Our Ref: 19292

RE: PROPOSED CHANGE OF USE OF PART OF GOLF COURSE TO CEMETERY INCLUDING ALTERATIONS, ADDITIONS AND CHANGES TO/NEW ACCESS FROM PARK ROAD – 13-15 PARK ROAD, WALLACIA

We refer to the letter from Transport for New South Wales dated 27th March 2020.

Swept paths of WSP Plans

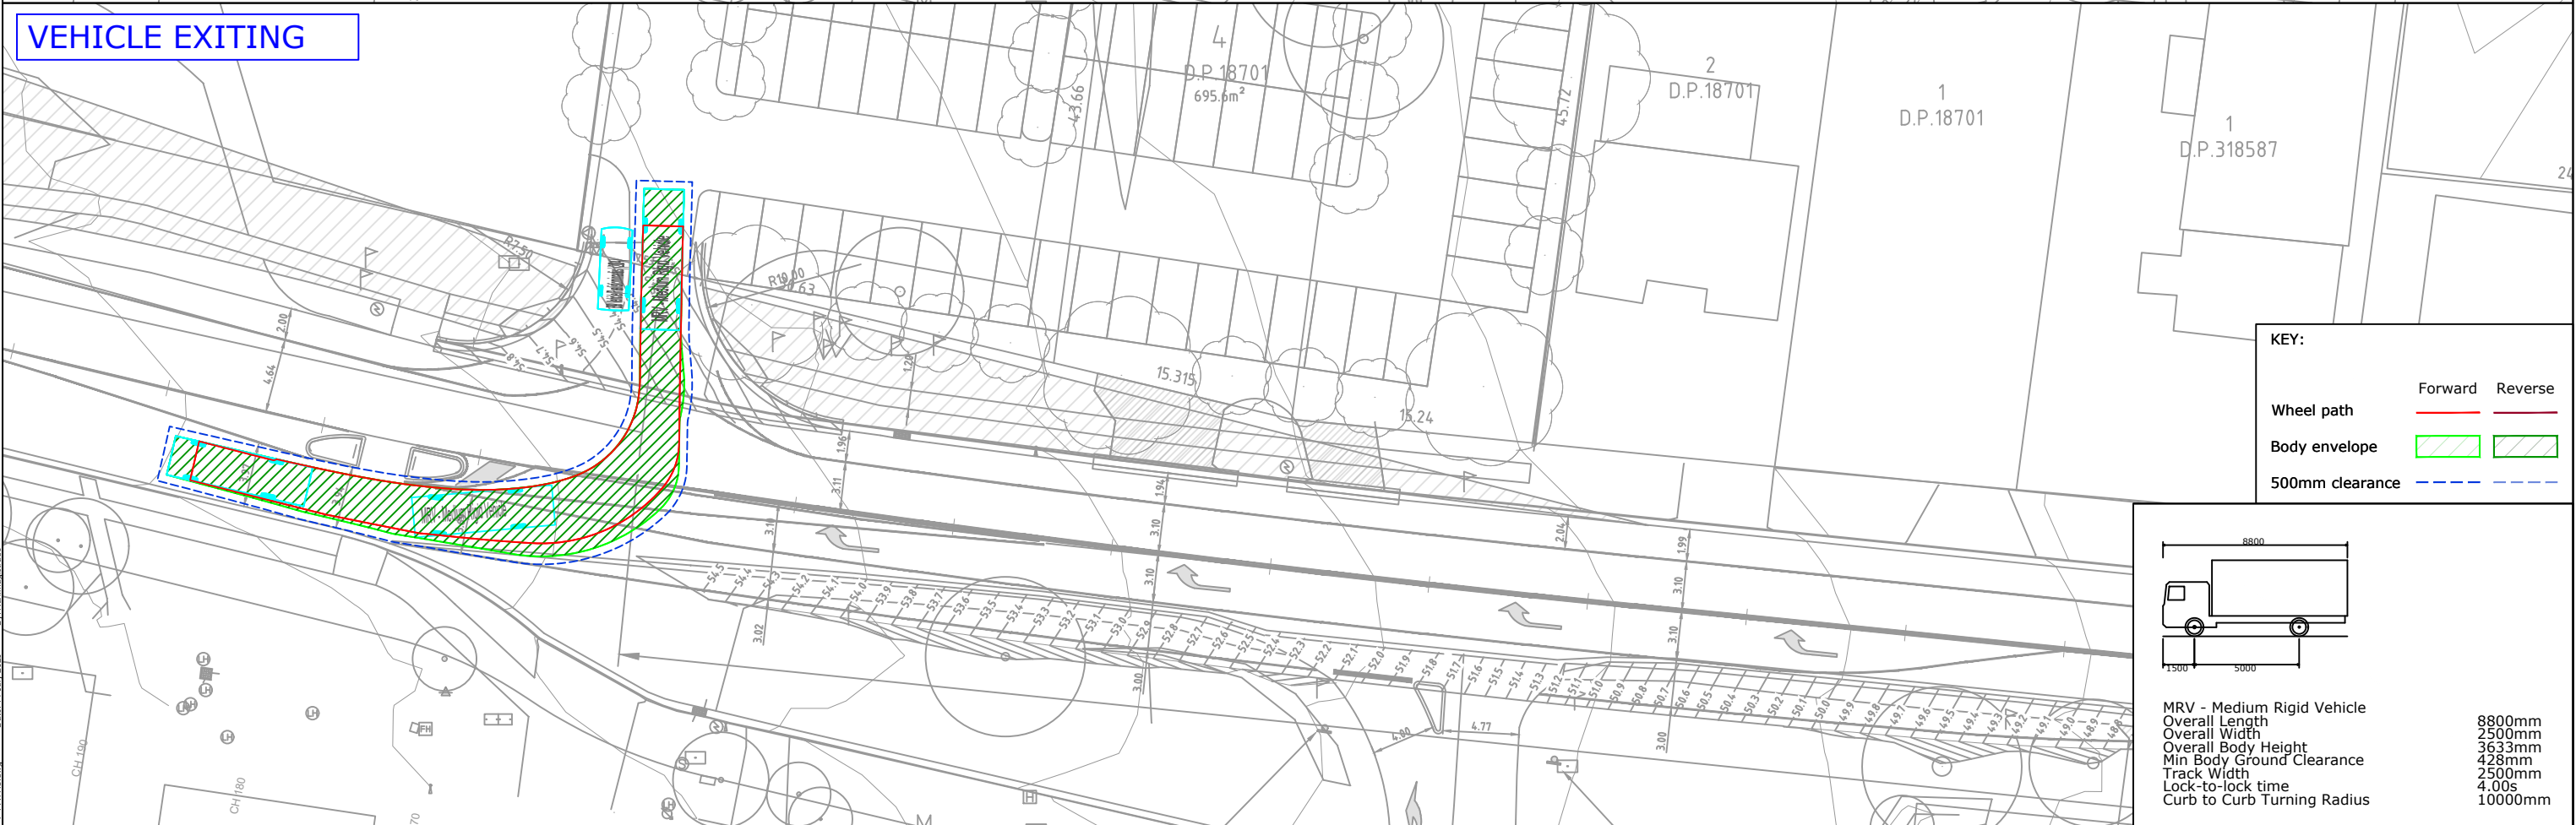
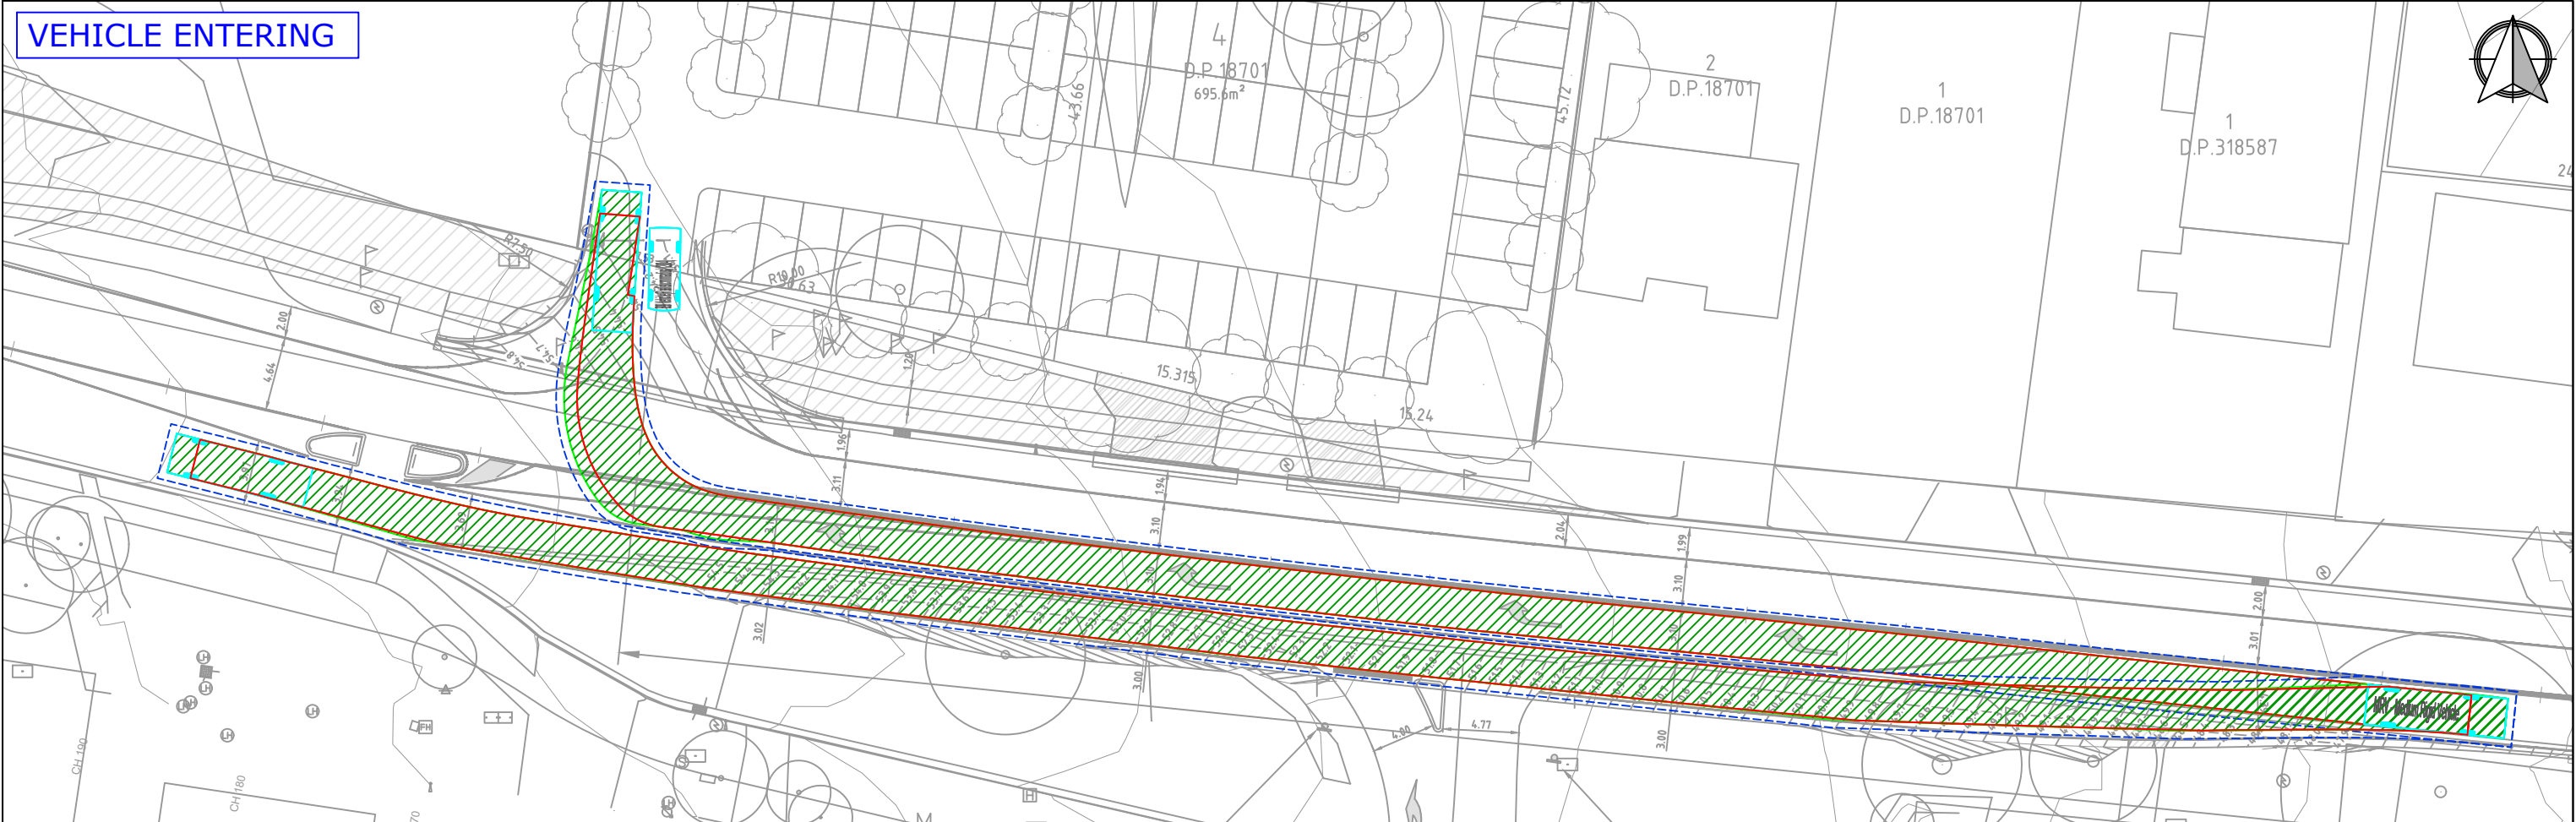
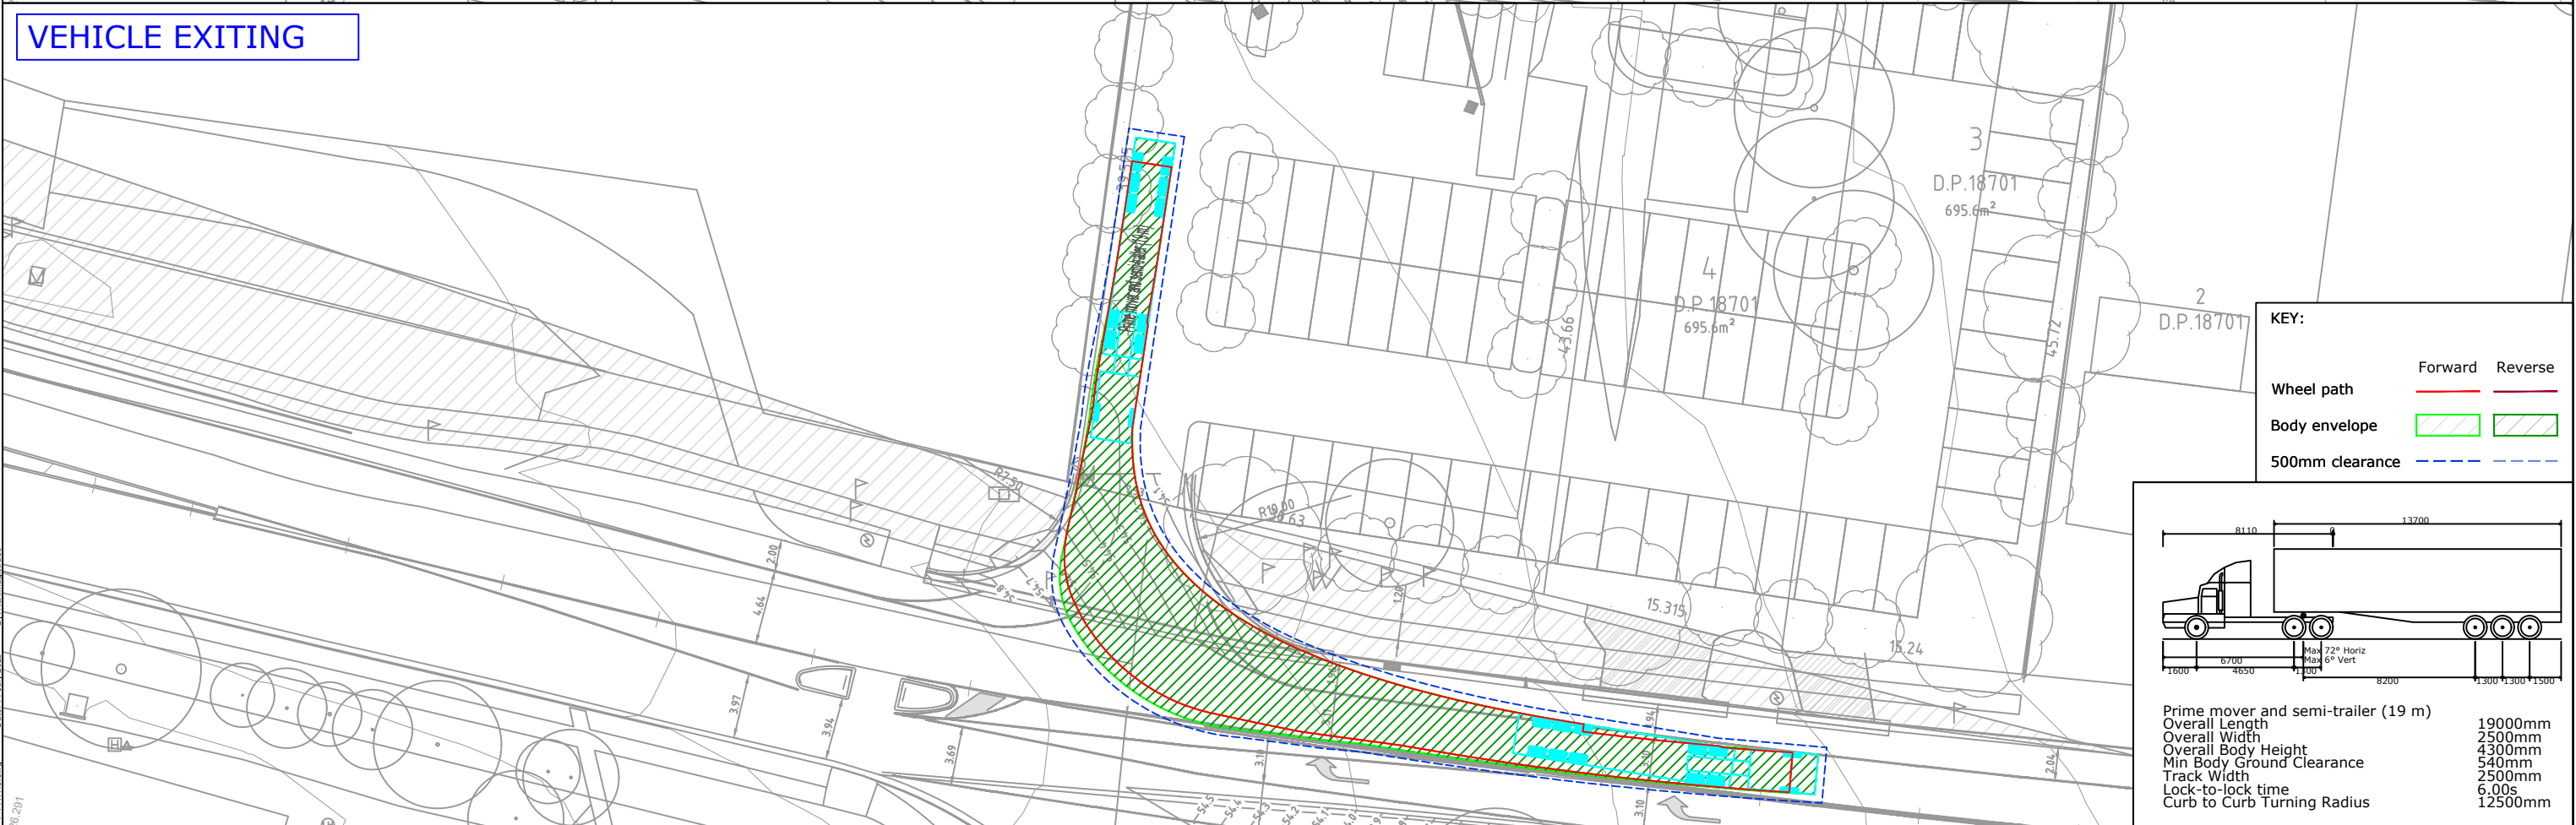
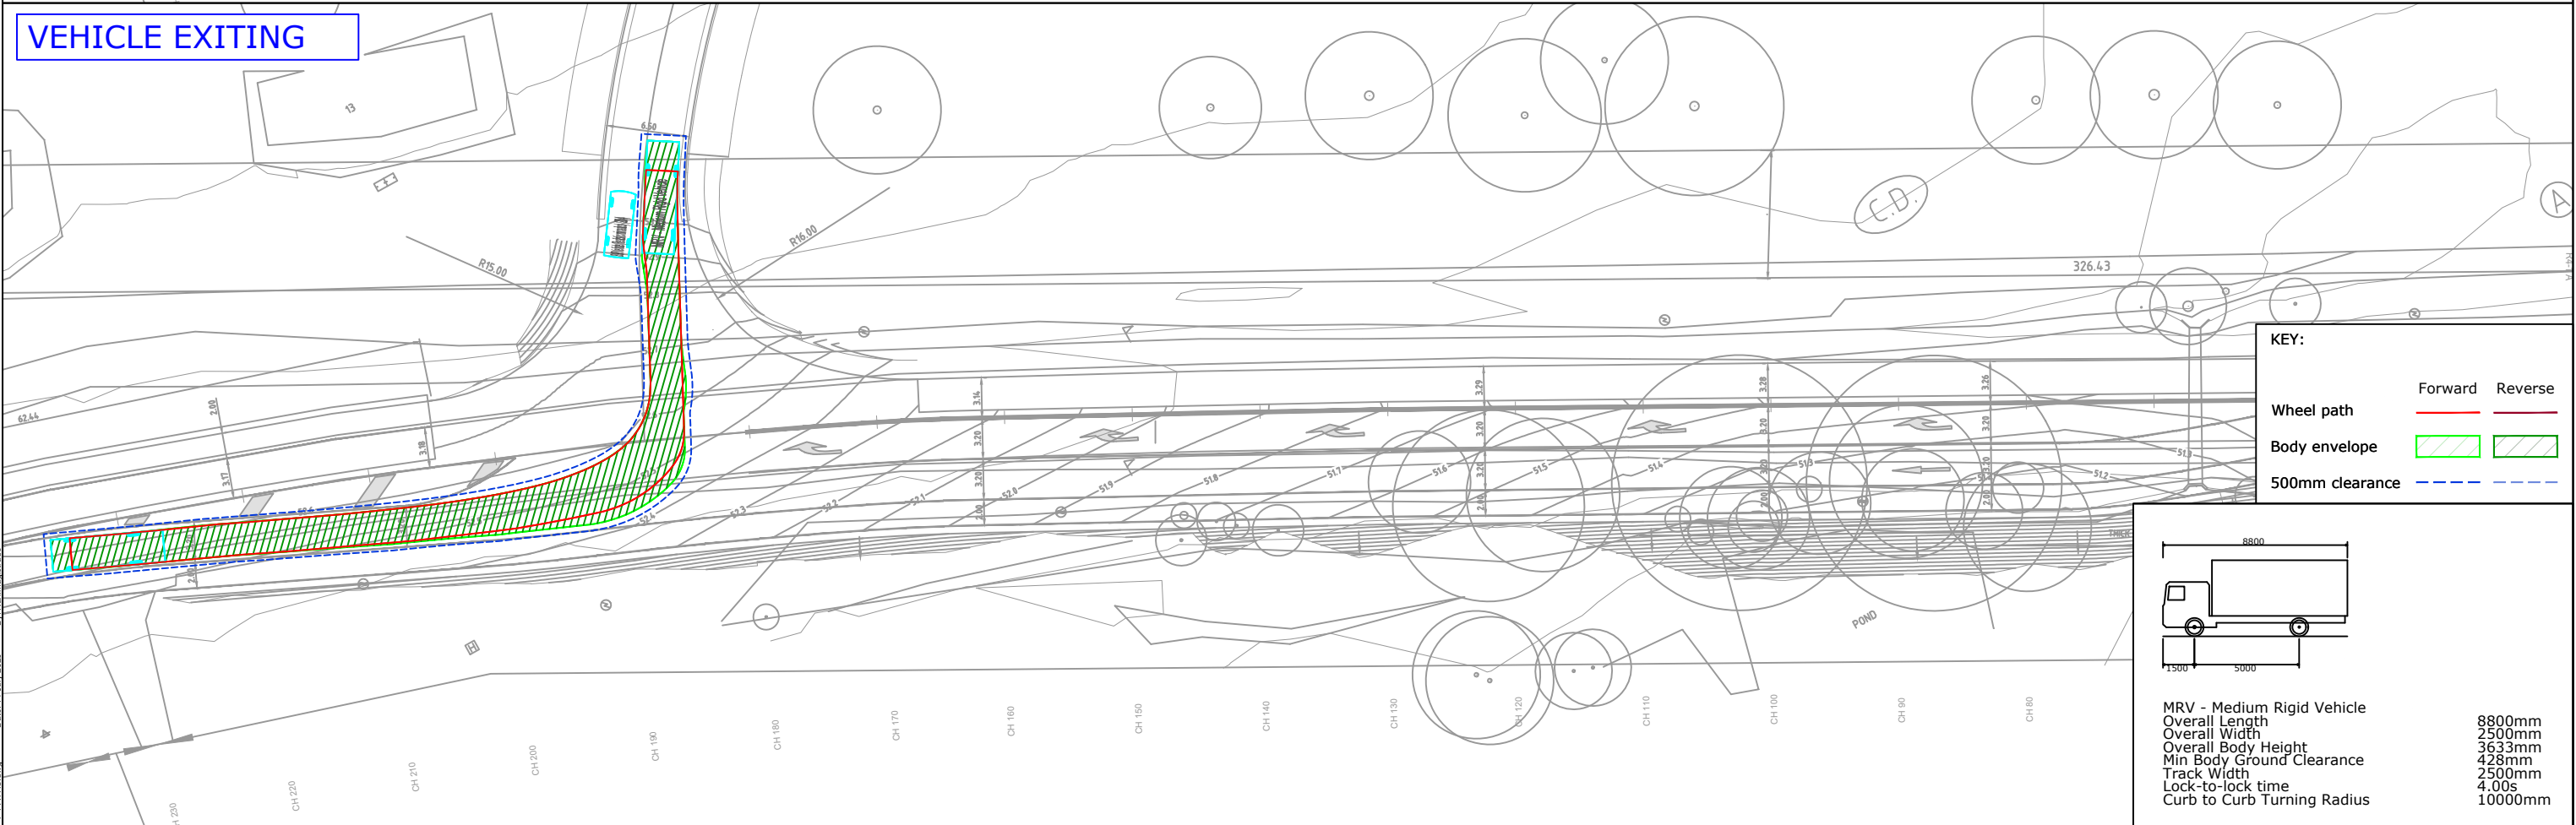
TfNSW now note that "the provided turn paths for an 8.8m vehicle provided are acceptable. Consideration should be given to larger vehicles (as a checking vehicle) for during construction it is likely 19m semi-trailers will be accessing the sites. In addition, the swept paths on Figure 9 depict a vehicle accessing/egressing the driveway from the wrong side of the road. Therefore, TfNSW requests updated swept paths to be provided which include a 19m checking vehicle and the swept paths in Figure 9 are to be flipped to the correct side of the road".

TTPP has undertaken swept paths on these new plans and there are contained at Appendix B.
